TRANS/WP.29/GRSP/2002/3
21 February 2002

PROPOSAL FOR DRAFT AMENDMENTS TO REGULATION No. 44
(Child restraint system)

Transmitted by the Expert from Sweden

Note: The text reproduced below was prepared by the expert from Sweden in order to introduce in Regulation No. 44 a definition of the floor pan on the test trolley described in annex 6. It is based on the text of a document distributed without a symbol (informal document No. 6) during the thirtieth session and supersedes document TRANS/WP.29/GRSP/2000/2.

Figure 1

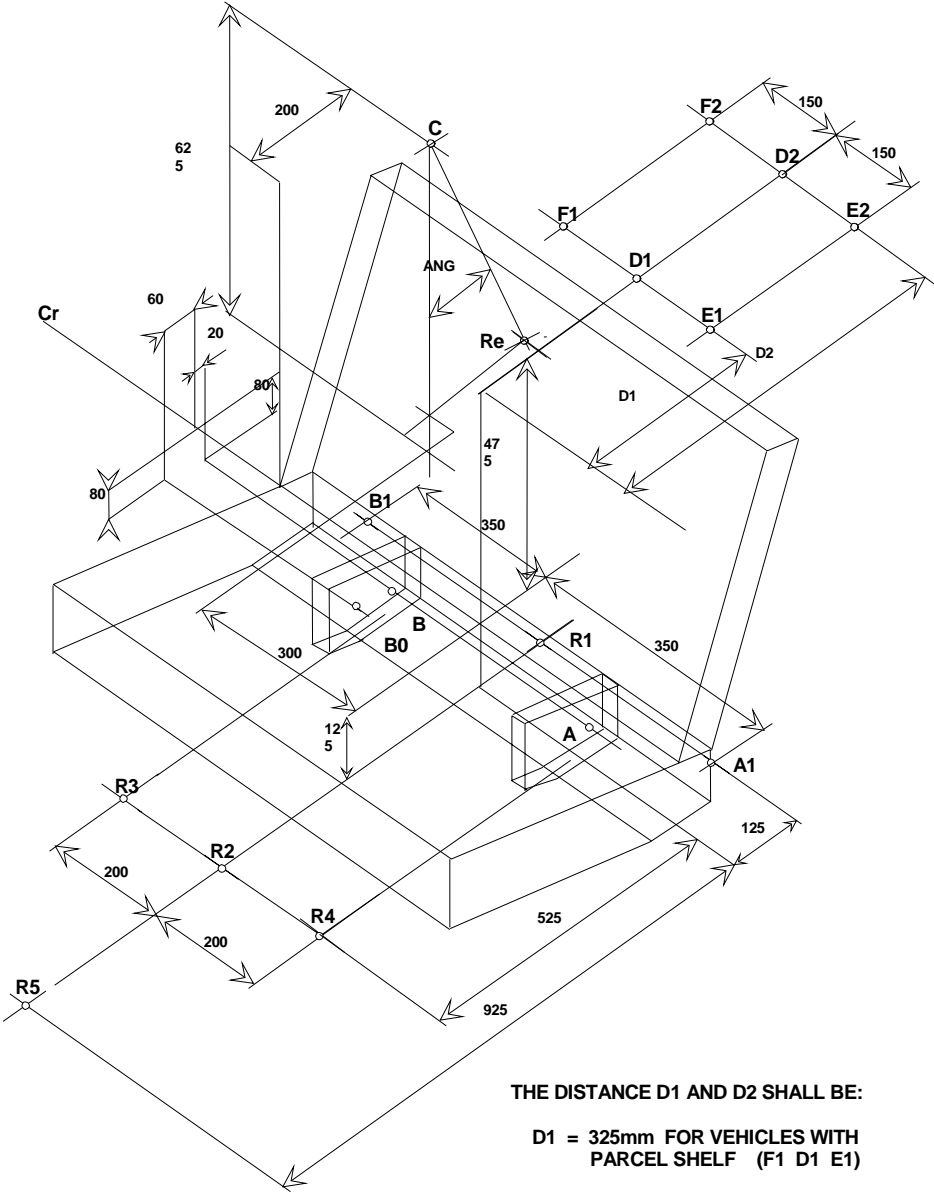
Annex 6, appendix 3, figure 1, amend to read:

THE DISTANCE D1 AND D2 SHALL BE:

- D1 = 325mm FOR VEHICLES WITH PARCEL SHELF (F1 D1 E1)
- D1 = 1025mm FOR VEHICLES WITH FOLDING BACK REAR SEATS (ESTATE TYPE) (F2 D2 E2)

DIMENSIONS REFERRING TO Cr
ARE TOLERANCED WITH: ± 2 mm
EXCEPT FOR DISTANCE FLOOR TO Cr ±10mm

DISTANCE C - Re = 550mm
ANGLE "ANG" = 30° MAXIMUM

Figure 2

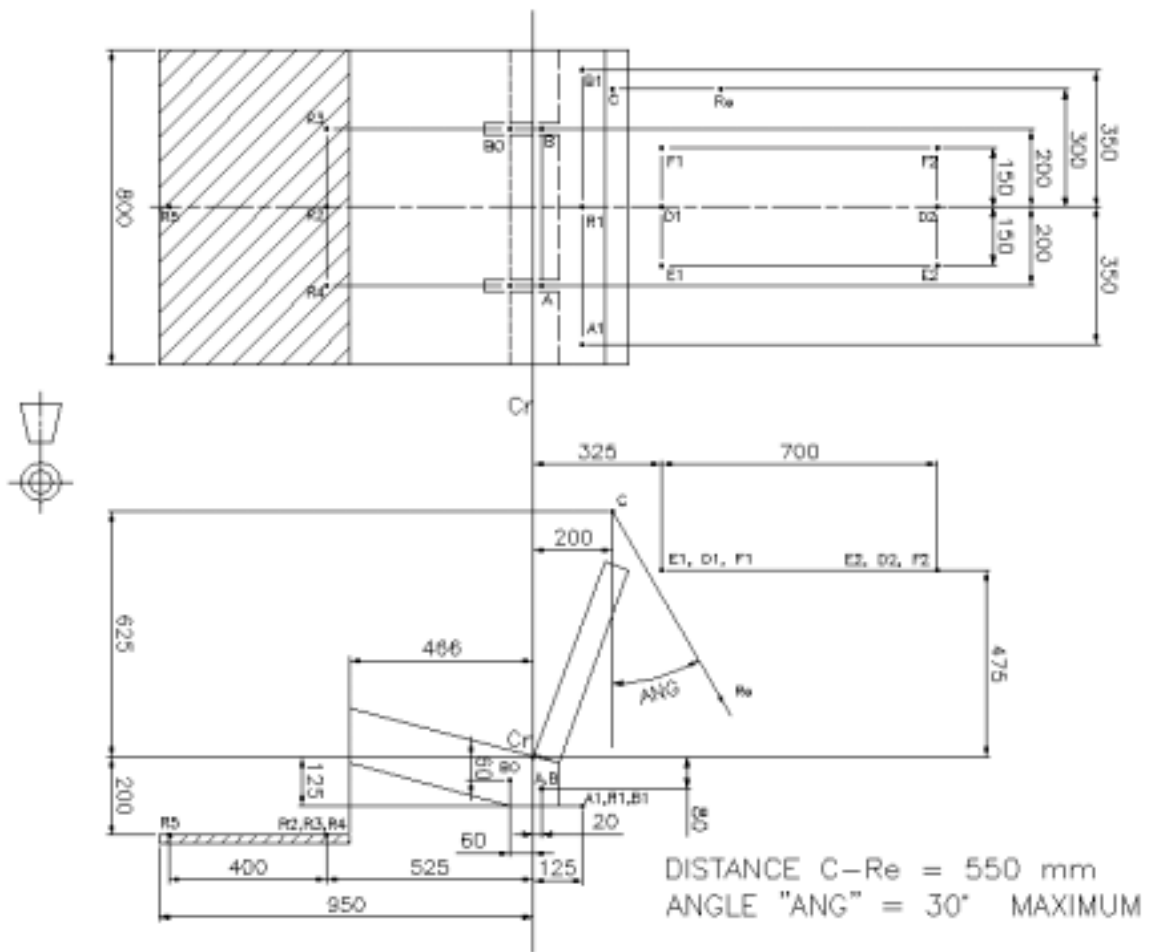
3.3.1. The floor pan of the trolley shall be constructed of a flat sheet of metal of uniform thickness and material, see Figure 2 of appendix 3 to this annex.

Annex 6, appendix 3, figure 2, amend to read:

FLOOR AREA IS HATCHED
